E8803A-02A

S E R V I C E N O T E

E8803A PNA Microwave Network Analyzers

Figure 1: A3 Front Panel Interface Board Assy without the Bracket

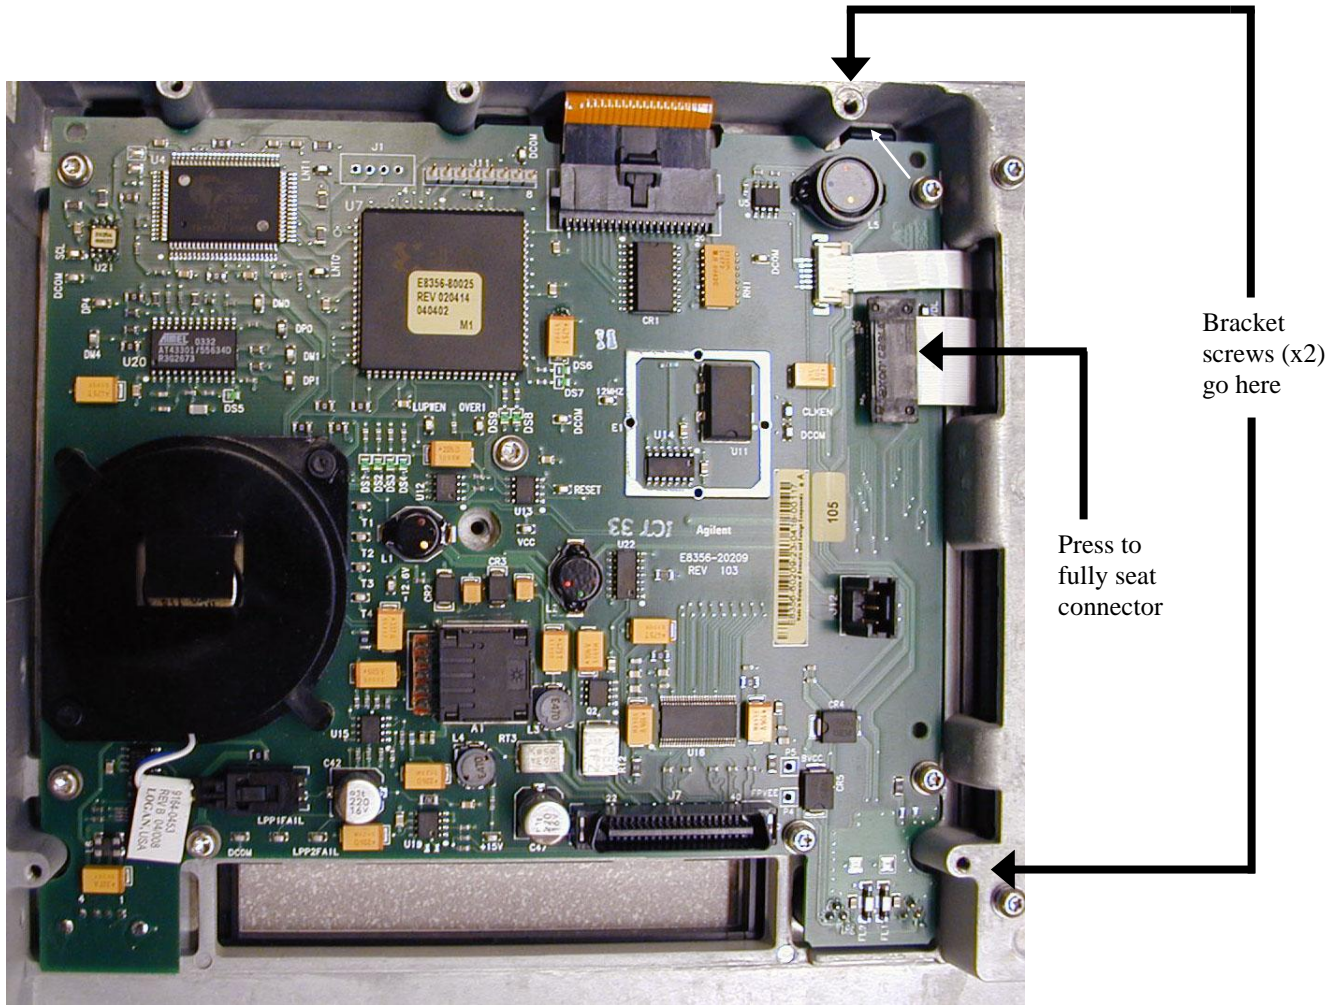
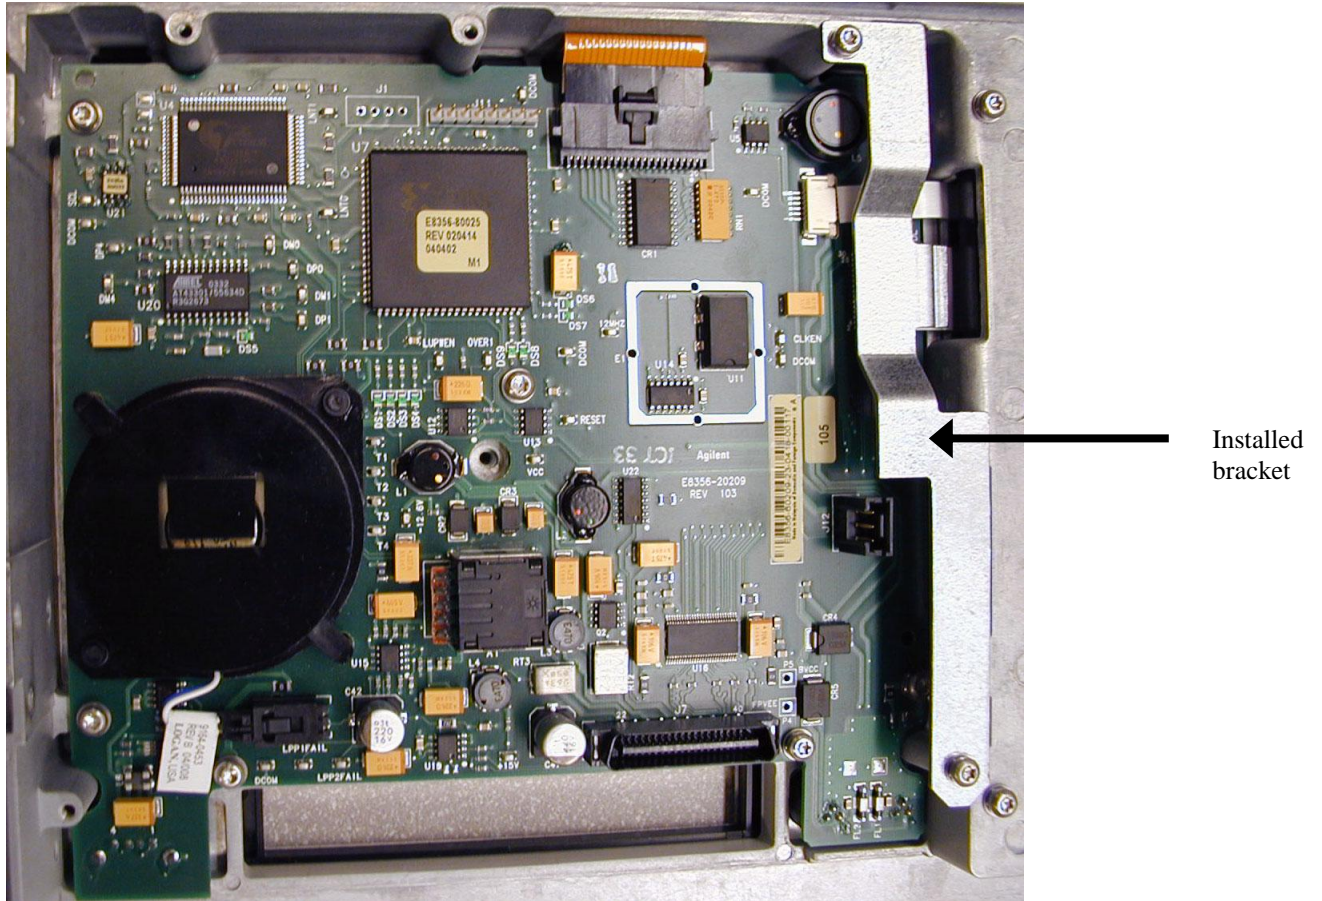
A connector of the ribbon cable (Agilent part number 8120-8409) that joins the front panel display to the front panel interface board can loosen, causing a display failure, unless a new bracket is installed. Because the failure rate has been very low, it is recommended that the bracket be installed only when there is an additional reason to remove the PNA front panel.

1. Refer to Figure 1 in this document:
 - Press down firmly on the ribbon cable's black connector.
 - Locate the two tapped holes for the bracket screws.
2. As shown in Figure 2 in this document, position the bracket so that its holes line-up with the two holes you located in the previous step.
3. Hand-start the two screws, and then torque both to 9 in-lbs.
4. Reinstall the PNA Front Panel by following the Service Guide instructions in the "Replacement Procedure." This is located on the same page as the "Removal Procedure" used previously in step 7.
